27 July 2020

Submission: Narrabri Gas Project

Figure 1: GAB recharge map taken from Ransley et al 2012. "Hydrostratigraphy, hydrogeology and system conceptualisation of the Great Artesian Basin"

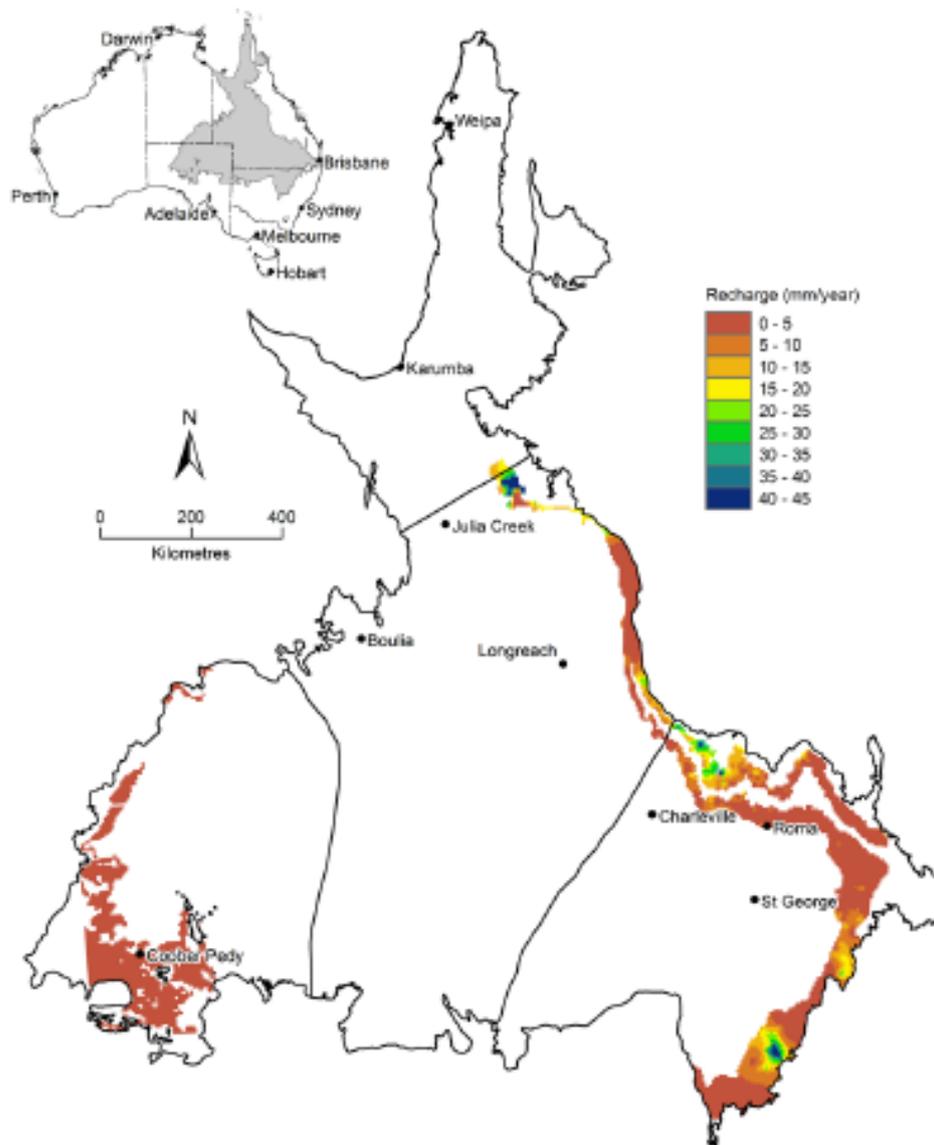
To support the claim that the Narrabri project is "not in a major recharge area" of the GAB, the Assessment Report includes grainy reproductions of images from unreferenced material from GISERA (Figures 21 and 22). The grainy reproduction was supplied by Santos in answer to WEP questions about the company's contention that the Pilliga Sandstone was not a "major" recharge area of the GAB. This would have been clear to the Department if they had viewed the source of Santos' supplied image of GAB recharge which they reproduce as Figure 22 in the Assessment Report.

Figure 22 shows only a narrow band of the eastern part of the GAB to compare the estimated 5mm a year recharge in the Pilliga Sandstone to the estimated 40mm a year in the Warrumbungles to the south. Had Santos and the Department provided the entire map from the source study for the image, the impression created about the relative importance of the Pilliga would have been very different, as Figure 1 below shows.
